Attachment E

Location and Type of NESC Violation

Re: Oncor Safety Violations

(17)

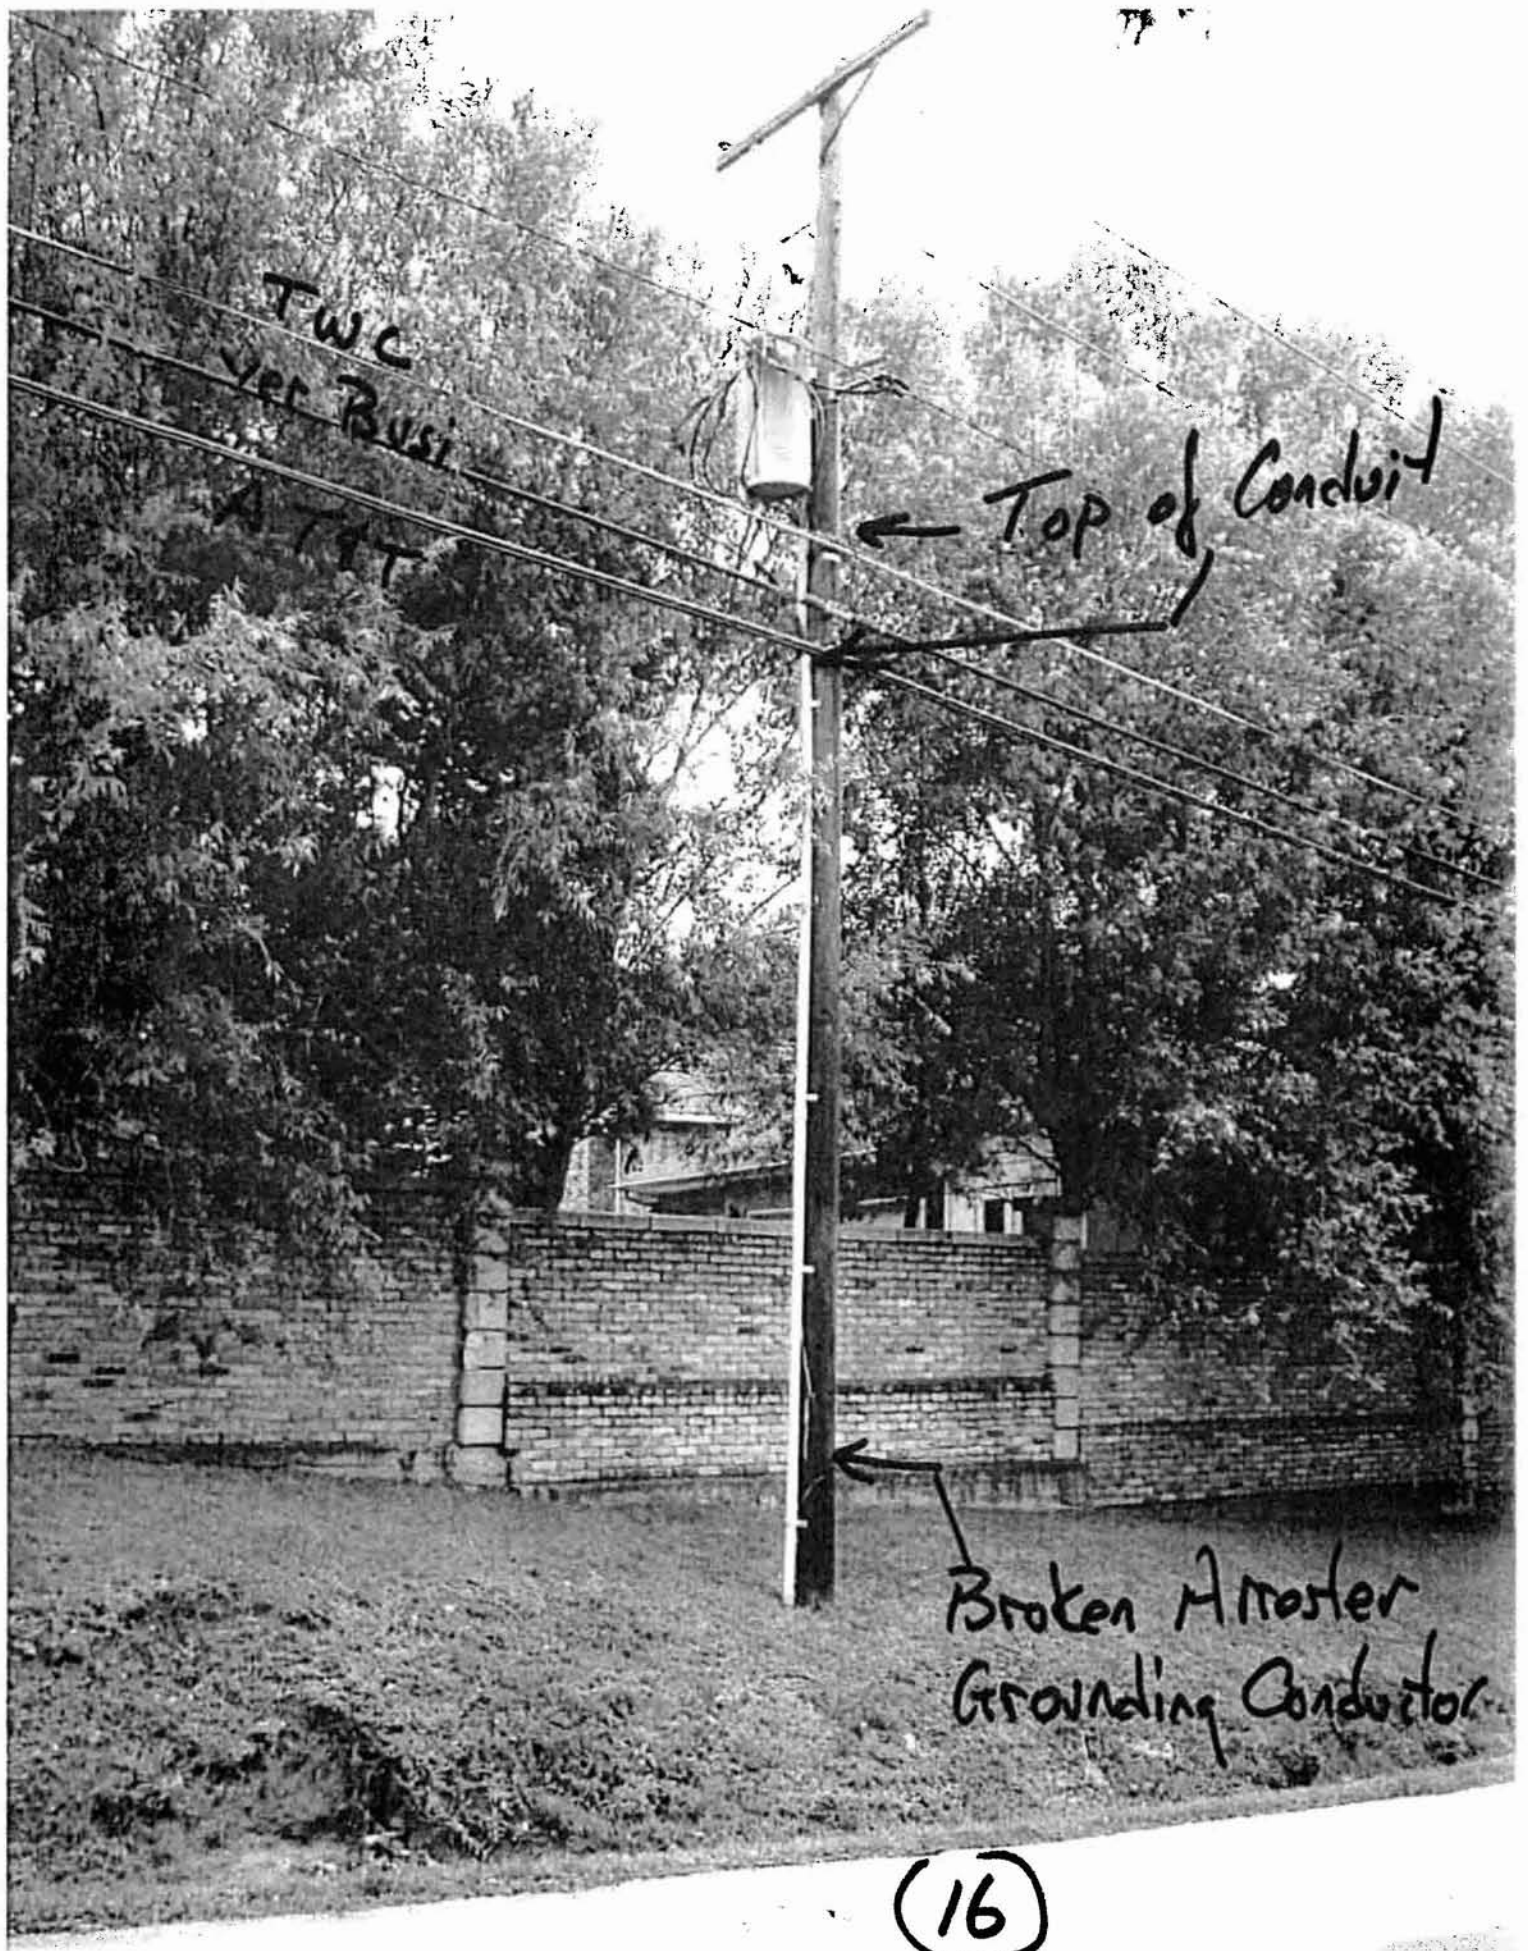
Bottom Transf
To TWC 1'-0"
To VBS 2'-4"

Broken Surge
Arrestor
Grounding Conductor

19

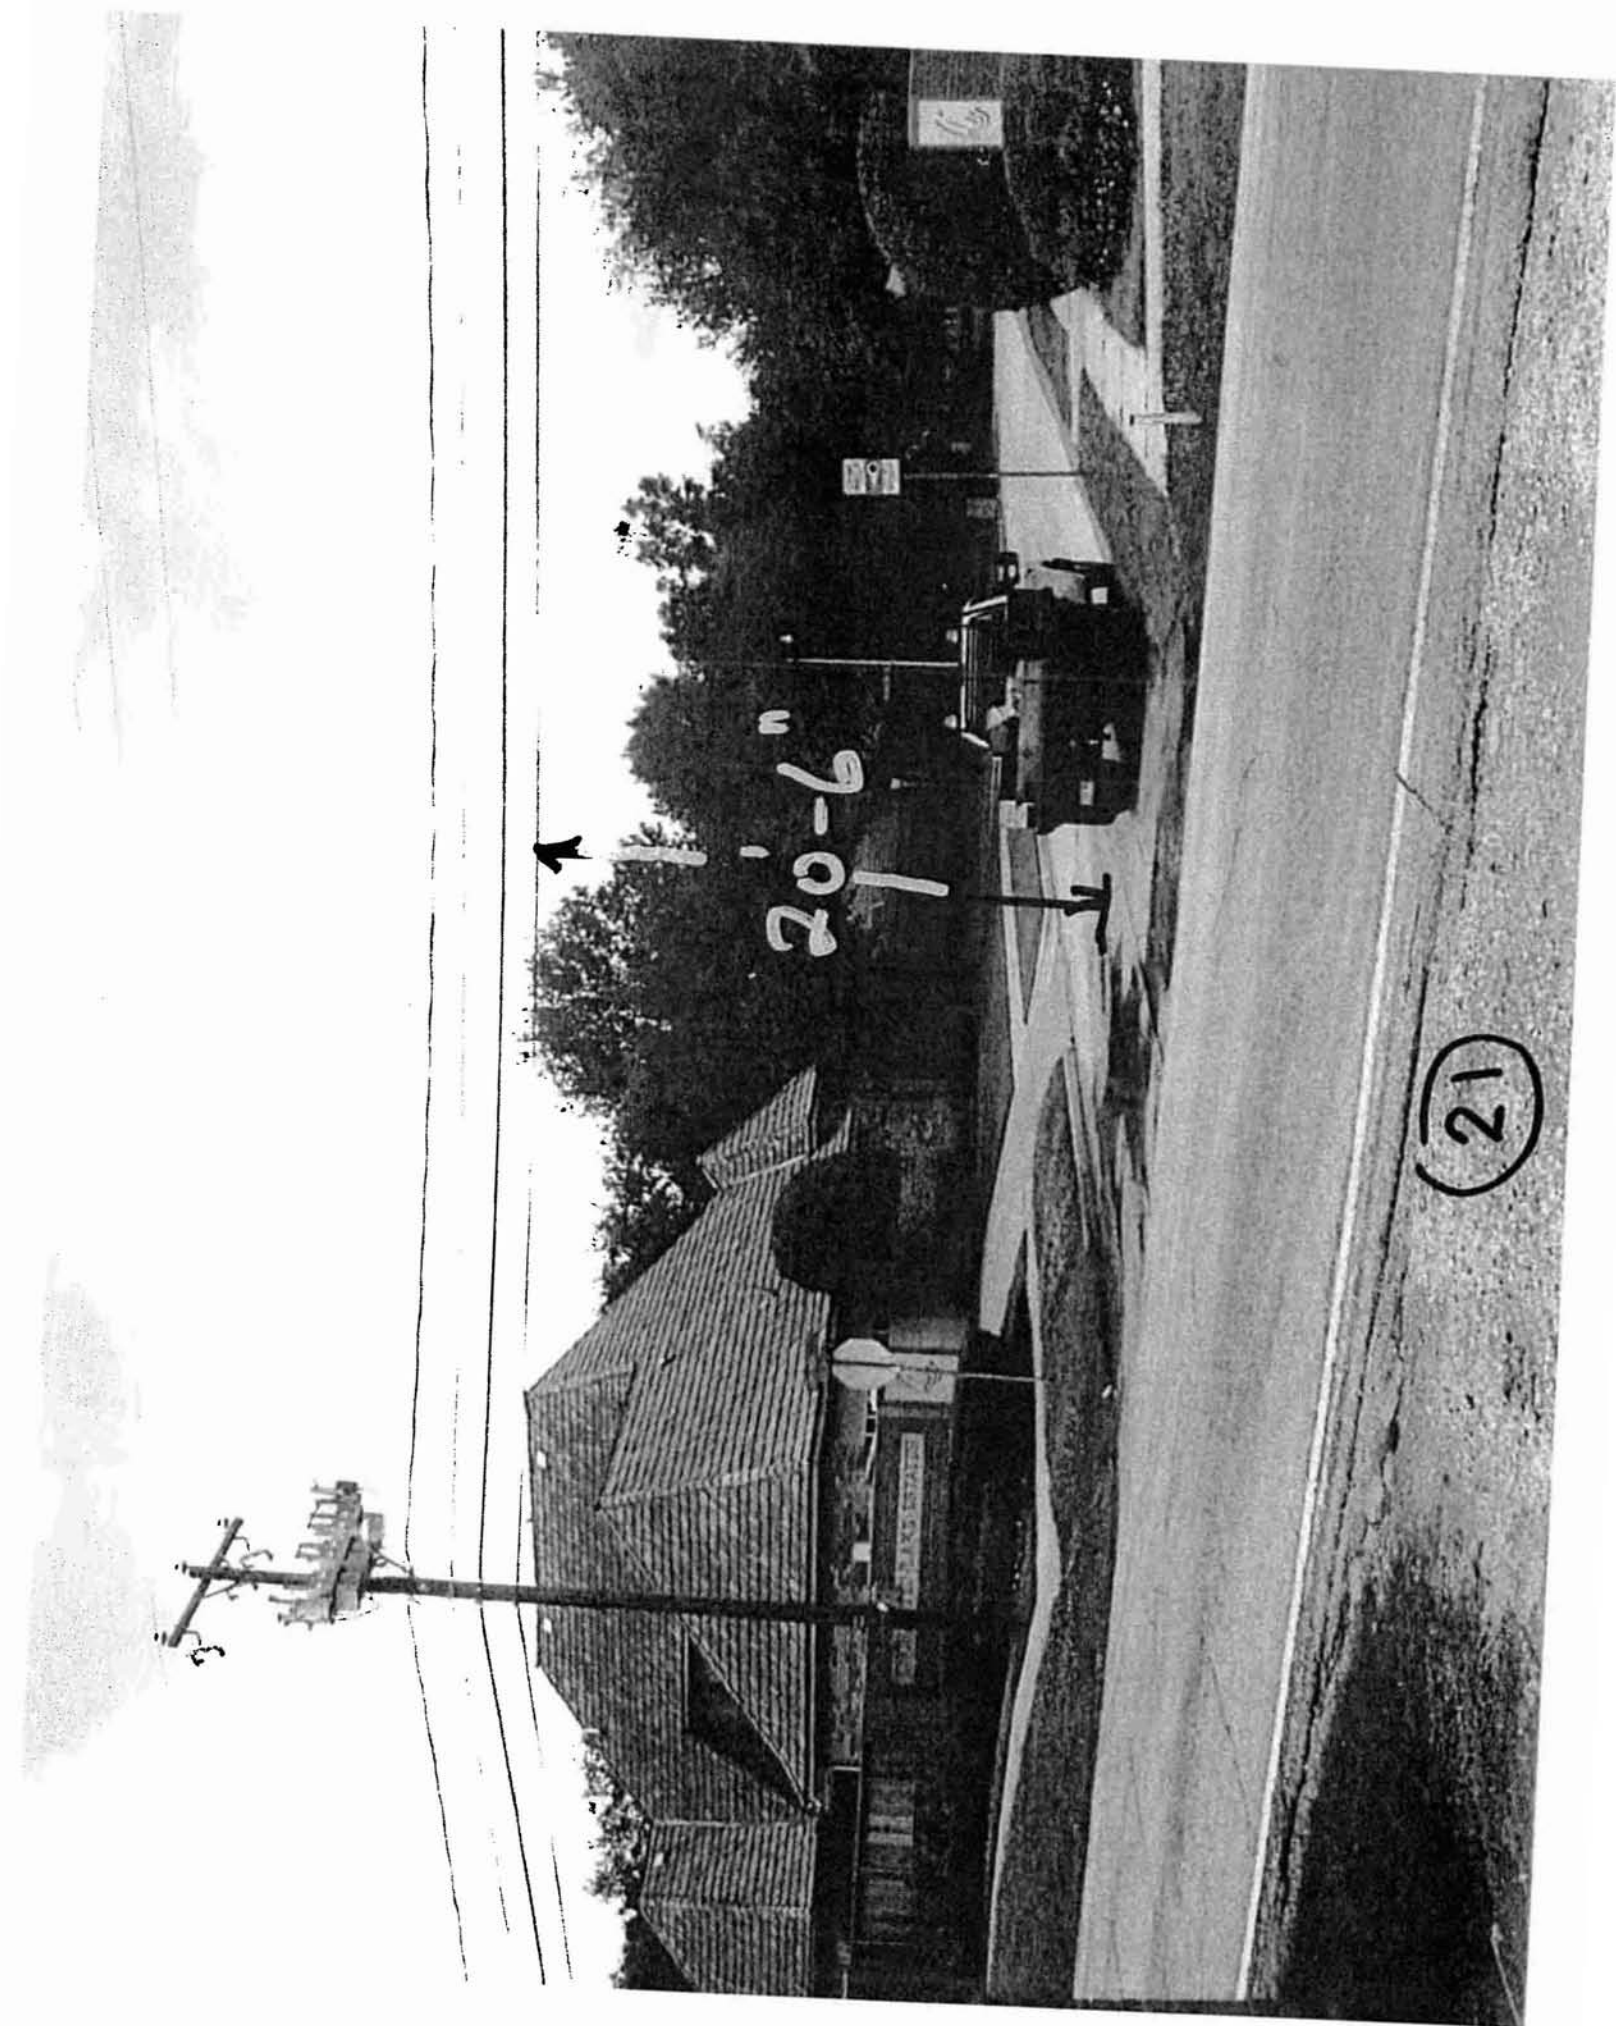
U-Guard to:
TWC 1'-10"
VB 2'-10"

Triplex loops
TXU triplex
TWC
VB AT&T

Triplex loops 7' 1'-7" 3'-2"
--- ↓ --- ↓ --- ↓ --- ↓
↑ ↑ ↑

TXU Broken St Lt Twin
Dead-end clamp

Sagging below TWC

(25)

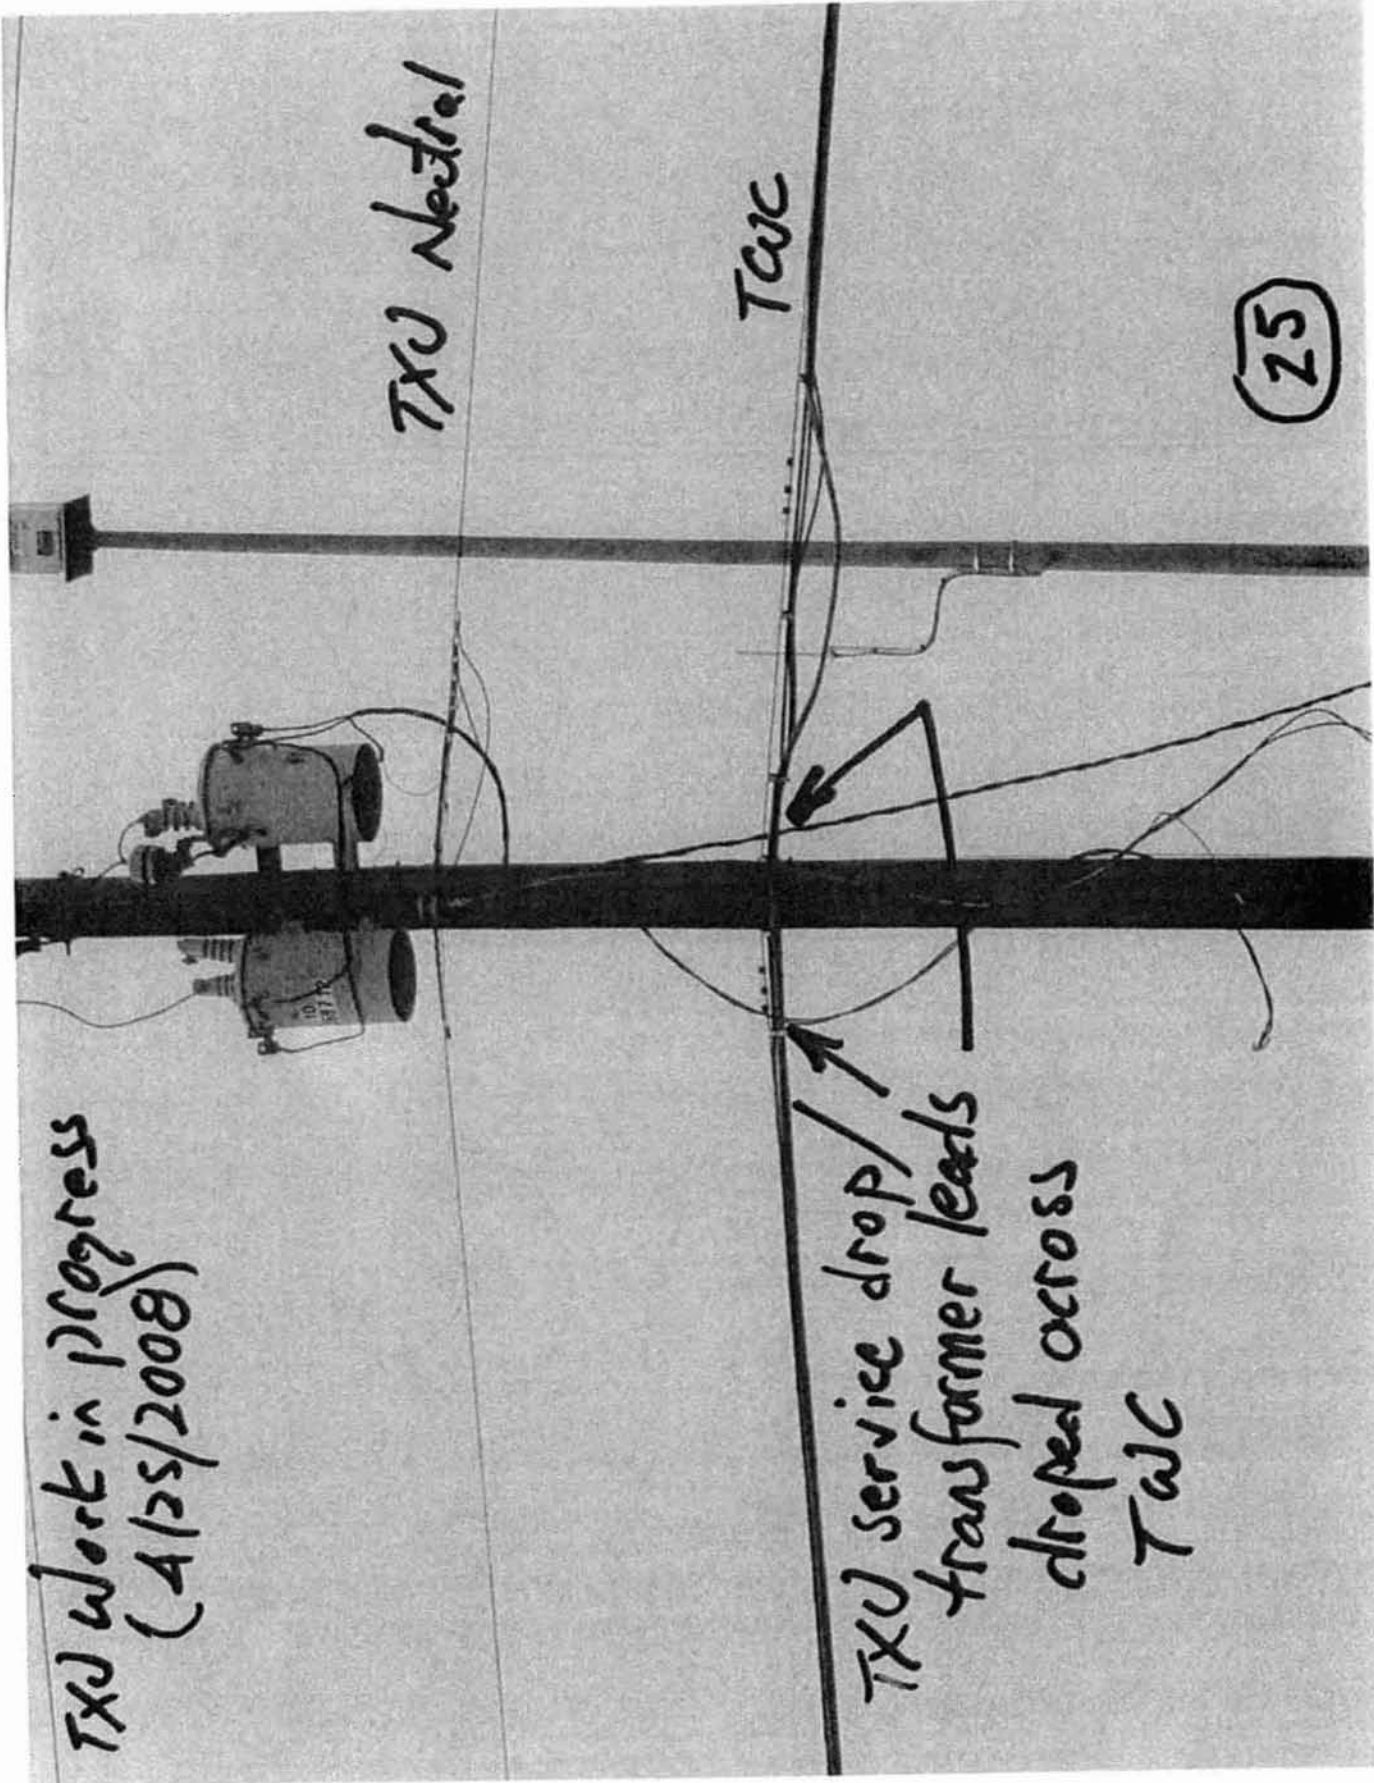
TXU service drop/
transformer leads
dropped across
TWC

TXU service
drop
not connected
